ADDENDUM No. 1

ITB No. 4606

Lift Stations Replacement Project Phase I

PROJECT MANAGEMENT - PUBLIC SERVICES - CITY OF ANN ARBOR
SCALE NO SCALE
DRAWING No. AC-04
SHEET No.

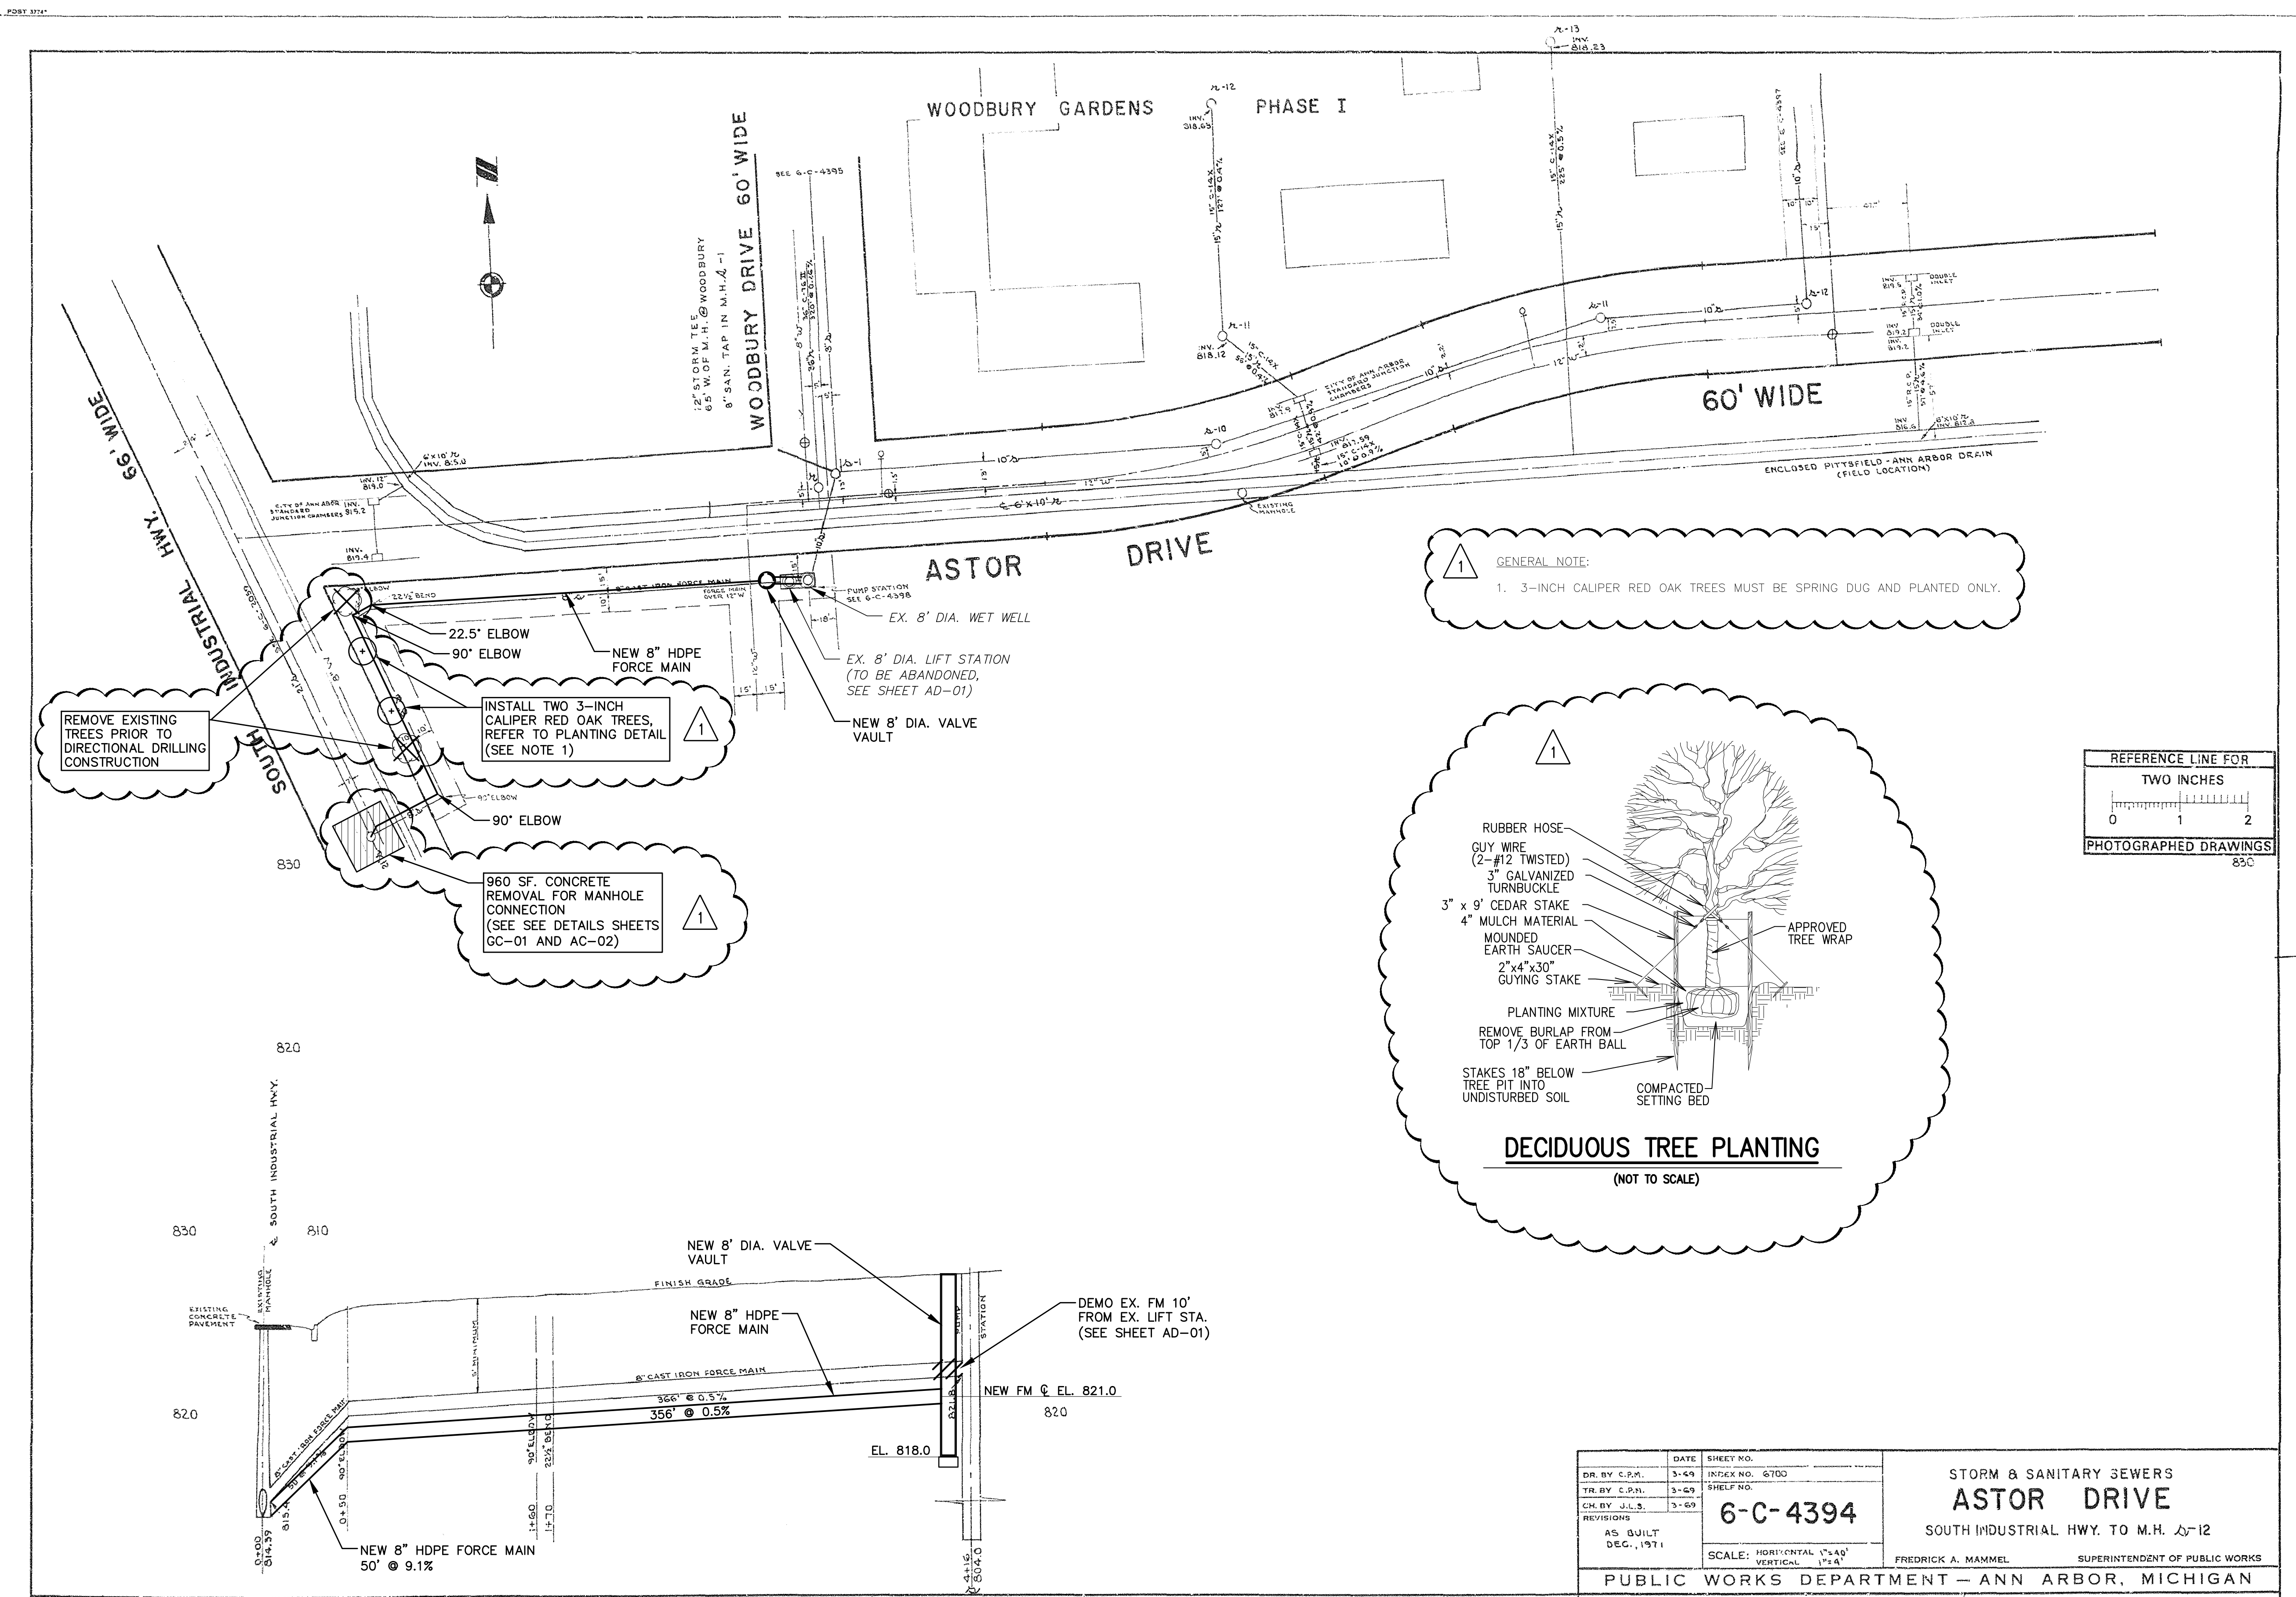
1. Are there any domestic requirements for the project?
RESPONSE: No, there are no domestic requirements for the project.
2. Where is the HDPE spec for the 8" HDPE force main and fittings?
RESPONSE: The specification for the 8" HDPE force main and fittings is included in the new Specification 02035 Horizontal Directional Drilling, which is attached.
3. Where the proposed 8" HDPE force main line ties into the 12" existing, what type of line is the existing?
RESPONSE: The Astor 8" HDPE force main ties into the manhole along the 21" existing sewer (not directly into the sewer), see re-issued sheet AC-04.
